S5000 TECHNICAL BULLETIN

| Date | 13/10/2021 |
|----------|------------------|
| Topic | Headrest |

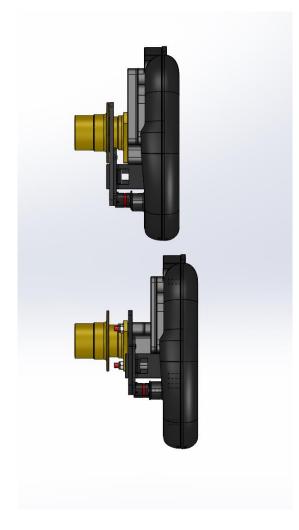
Teams have modified the headrest behind the helmet. We weren't given Motorsport Australia/FIA approval for the modification and have been told to return the headrest material around the helmet to the original design.

Clearance of the headrest around the hands and wrists were made by the individual teams and it doesn't look professional.

All headrests will be recalled to GRM and a Kevlar patch will be bonded in to return the back of helmet surface to the original design.

For taller drivers where space is an issue, an optional steering wheel housing (GRM-AI0512) will be available for purchase that allows for the steering wheel to be moved a maximum of 19.5mm forward and adjusted with 5mm spacers. It may be required to adjust or remake the driver's foam seat insert to push them forward.

A Kevlar patch that is shaped with a large clearance around the wrist will be bonded in to improve the appearance of the headrest.

After this work has been completed to the headrests no other modifications will be allowed.
